AIRWORTHINESS DIRECTIVE

- TYPES AFFECTED: Powered sailplanes fitted with Rotax 535 (A, B and C) engines.
- SUBJECT: Security of the charging and lighting coils on the armature plate assembly.

Subject : Fixation of charging coil and lighting coil on armature plate ass'y.

Models affected : Motorised glider engine type 535, all engines of execution A, B and C.

Fig. 1

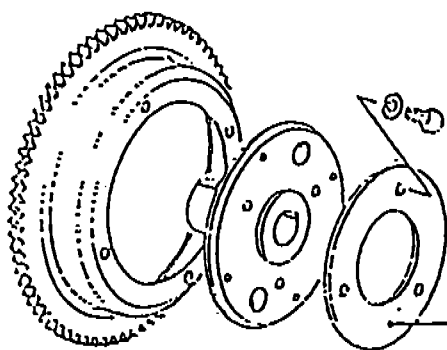
- 1.1. Remove cover washer (if existing) by unscrewing three bolts
socket spanner, size 13 A/F. Reassembly not foreseen.
- 1.2. Fasten flywheel fixture (876 080) with three hex. hd. screws
M8 x 16.
- 1.3. Remove crankshaft hex. nut M22 x 1,5 with socket spanner,
size 30 A/F.
- 1.4. Place protection cap or mushroom-like protector (876.557) to
crankshaft end, fasten puller to flywheel fixture and pull
off magneto housing. Use suitable spanner, size 22 A/F.

2) Overhaul of coil fixation: Fig. 3 on page 5

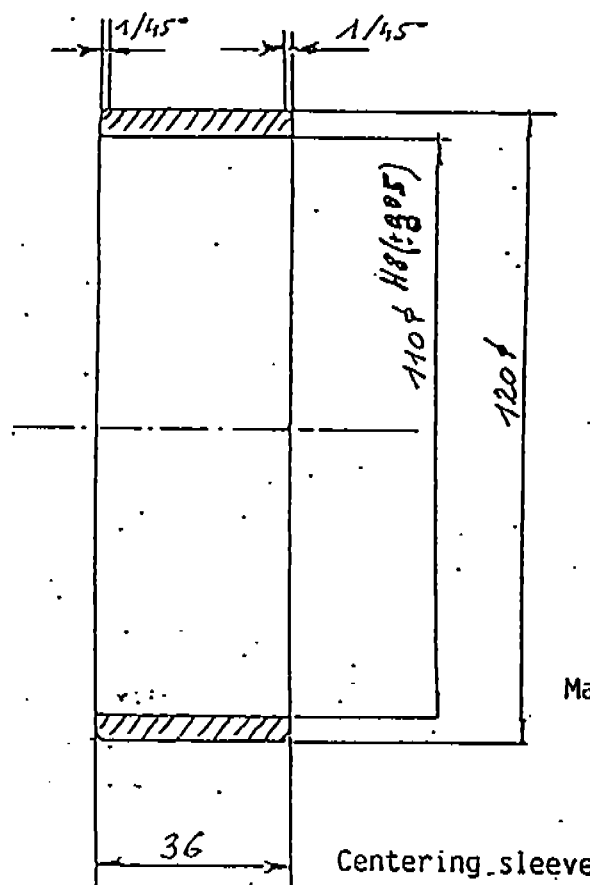
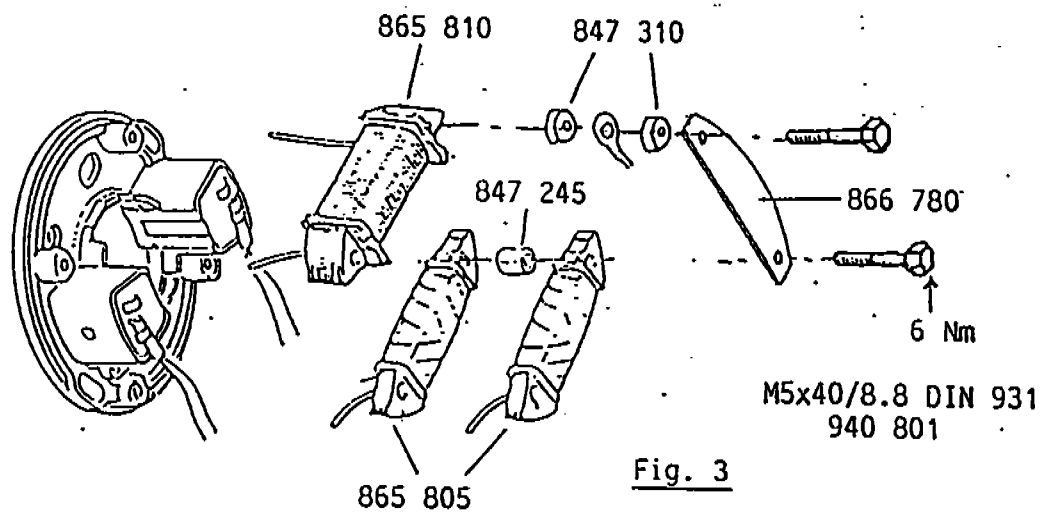
- 2.1. Clean armature plate ass'y.
- 2.2. Remove both coils..
- 2.3. Check coils for signs of wear, damage on holes and contact faces. Exchange as required. Clean contact surfaces to provide good contact.
- 2.4. Use new hex. screws M5 x 40, 8.8, DIN 931, Rotax p.n. 940 801 instead of previous screws.
- 2.5. Apply Loctite 221 to screws and contactfaces and slightly fasten screws.
- 2.6. Place centering sleeve (fig. 4 on page 5) over armature plate, push coils outwards and tighten screws. Screw torque 6 Nm.

Remark: Centering sleeve absolutely necessary to achieve correct distance between poles and magneto.
